Campaign code:
L74X-A.22.25

Campaign name:
Hood puffer washer rust

Model:
Revuelto

L74X-A. 22.25	To: After Sales Official Network Subject: Hood puffer washer rust Date: 15/09/2025 Pages 4	
--------------------------------	---	--

OPERATION B Repair method:

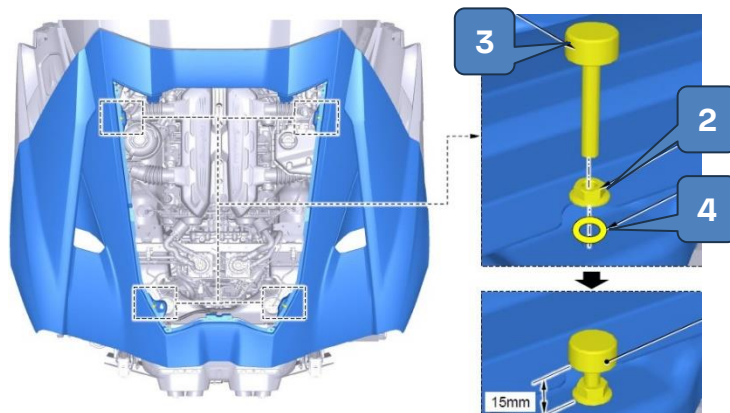
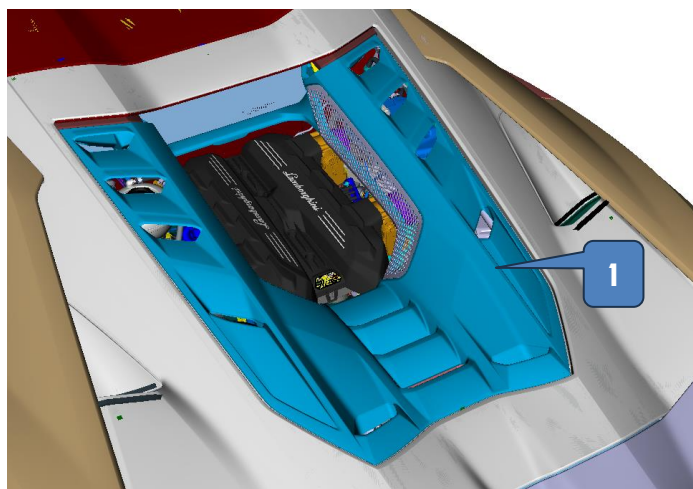
Information for the service network:
As part of the continuous monitoring of the product, Automobili Lamborghini S.p.A. requires the washers of the engine bonnet stoppers to be removed

1. Open the rear bonnet (1).
2. Loosen the nut (2).
3. Unscrew the stopper (3) gauge by removing it completely.
4. Remove washer (4).
5. Re-tighten the stopper (3) until the nut (2) is flush.
6. Before tightening nut (2), ensure that there is a distance of approximately 15 mm between its base and the bottom of stopper (3). Then, tighten nut (2) with a torque of 3.3 Nm.
7. Carry out the operation on all four stoppers.
8. Once the procedure is complete, close the engine bonnet (1) and check that it is aligned correctly. If it is not aligned correctly, adjust the four stoppers (3) until it is.
